PUBLIC INTEREST REVIEW FOR GROUNDWATER APPLICATIONS

SUBJECT: Application G- 17944 Supersedes review of _____
Date of Review(s)

A. GENERAL INFORMATION: Applicant's Name: Roy Vardanega County: Grant

Application G-17944, Roy Vardenega

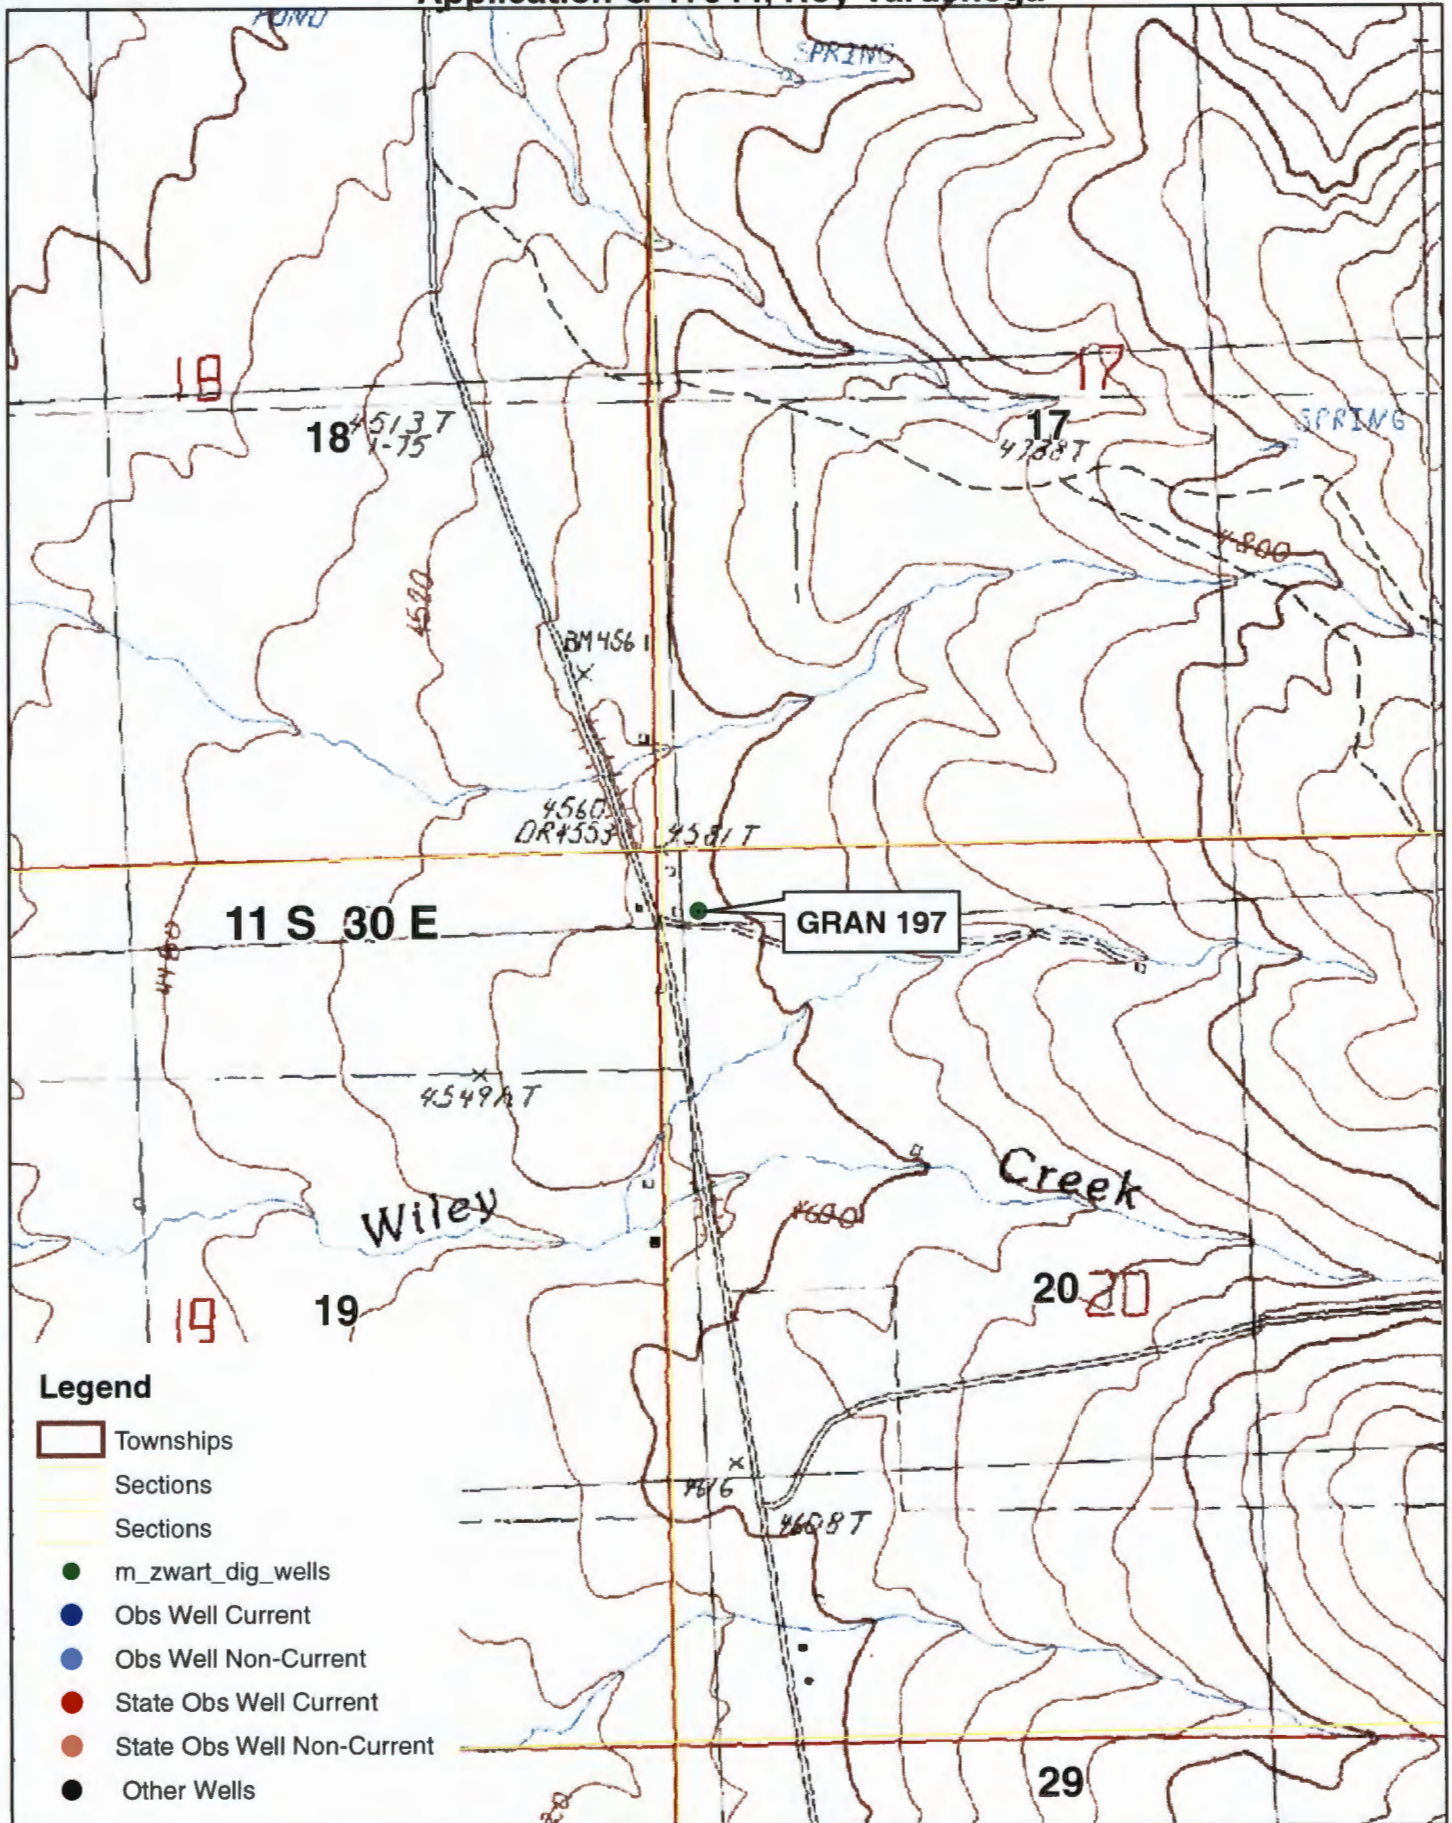
Basis for aquifer hydraulic connection evaluation: The water-bearing zone of GRAN 197 is approximately elevation 4505 ft. The regional geologic map indicates that the Columbia River Basalt is mapped at the surface in the vicinity of the local reaches of the creeks and at the two springs. The determination of hydraulic connection is often problematic with basalt aquifers, especially if the local dip of the basalts is unknown. Therefore, I am unable to make a positive finding of local hydraulic connection. However, hydraulic connection is possible with any of these surface water sources, but is judged to be more likely with Spring #2, based on its similar elevation.
